Project **IEEE 802.16 Broadband Wireless Access Working Group** <<http://ieee802.org/16>>

Title **CMAC/HMAC-Digest Generation Method using the EIK**

Re: IEEE P802.16e/D9

Proposed Changes into IEEE P802.16e/D9

Figure 136-HMAC/CMAC authentication key derivation from EIK

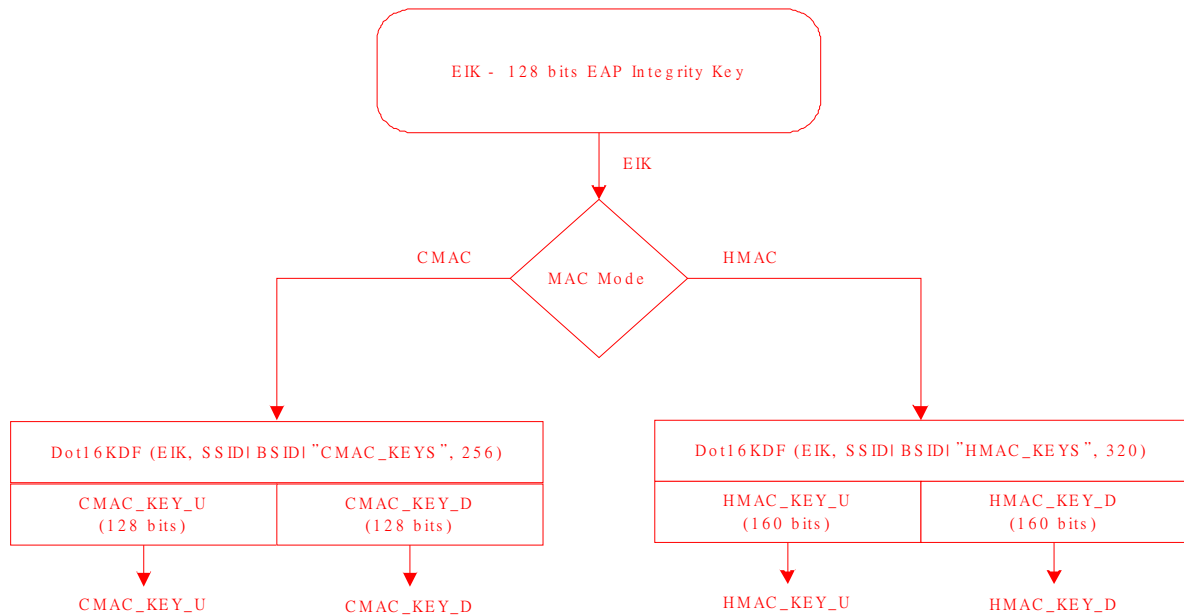
[Add following contents below Figure 135 in sub-clause 7.2.2.2.10]

Figure 136 outlines the process to calculate message authentication keys derived from the EIK. The message authentication keys are used to generate the CMAC value or the HMAC-Digest included in a PKMv2 Authenticated-EAP-Transfer message.
